MC34709, Silicon Errata (N88D)

This errata document applies to the MC34709 data sheet.

Figure 1. RTC Workaround Application Circuit

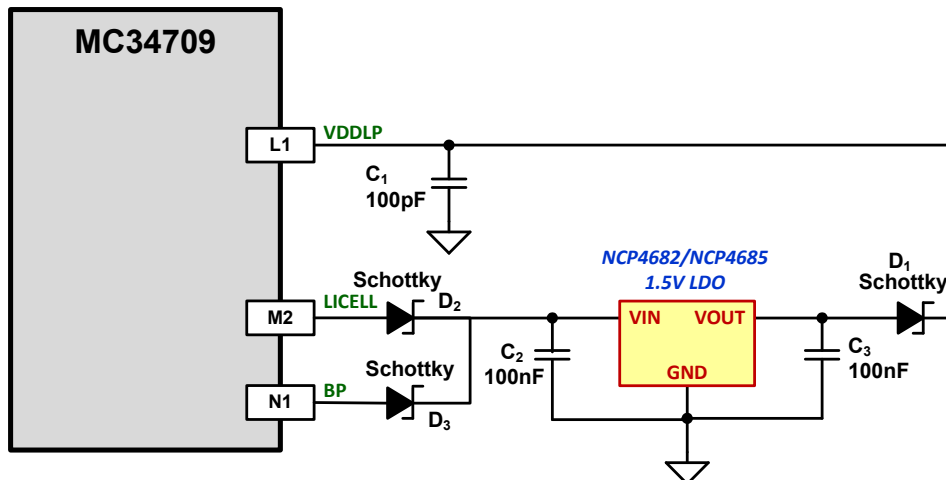
Errata Number	Erratum	System Impact	Description
High Severity Level			
4	Buck Regulator: Regulator output undershoot in APS mode.	Undershoot may cause processor to shutdown.	In APS mode the regulator output may undershoot for approximately 10 μ s under transient loads of 1/2 of max rated current. Output voltage may drop as much as 160mV. Workaround: SW1-5 must be operated in PFM mode for loads lower than 100 mA and in PWM mode for loads greater than 100mA in order to meet the transient load response specification. Fix Plan/Status: No fix scheduled.
5	RTC: VSRTC drops out with slowly decaying battery and a valid coin cell.	In applications with a Li-Ion battery, the RTC can be lost when the battery voltage drops to \sim 2.2 V. In applications where VBATT is driven by an external source, the RTC can be lost as the voltage transitions below the 2.2 V range during power down.	There is an issue with the 'Best of Supply' switch, which powers VDDL. During the change over from the primary power source to the coin cell, the VDDL can dip to a voltage below the minimum voltage required to power the RTC. <ul style="list-style-type: none"> The VSRTC supply is derived from VDDL, and therefore affects the RTC of the application processor, as well as the on-board RTC The 32 kHz clock to the processor's SRTC also drops out. Workaround: Figure 1 is the application circuit recommended for all applications where the RTC is used with a back-up coin cell attached to the MC34709. The LDO output is set to 1.5 V with a Schottky diode in series which keeps the voltage supplied to VDDL below the VCOREDIG (1.5 V). <ul style="list-style-type: none"> Add a low quiescent current 1.5 V LDO, supplied by the coin cell (LICELL pin). Recommended LDO: NCP4682/4685⁽¹⁾ or equivalent with a 1uA typical IQ. Add a low voltage Schottky diode (D1) to block the output capacitance (C3) of LDO. Add a low voltage/low leakage Schottky diode (D2) from LICELL to VIN of the LDO. Add a low voltage/low leakage Schottky diode (D3) from BP to VIN of the LDO. Fix Plan/Status: No fix scheduled
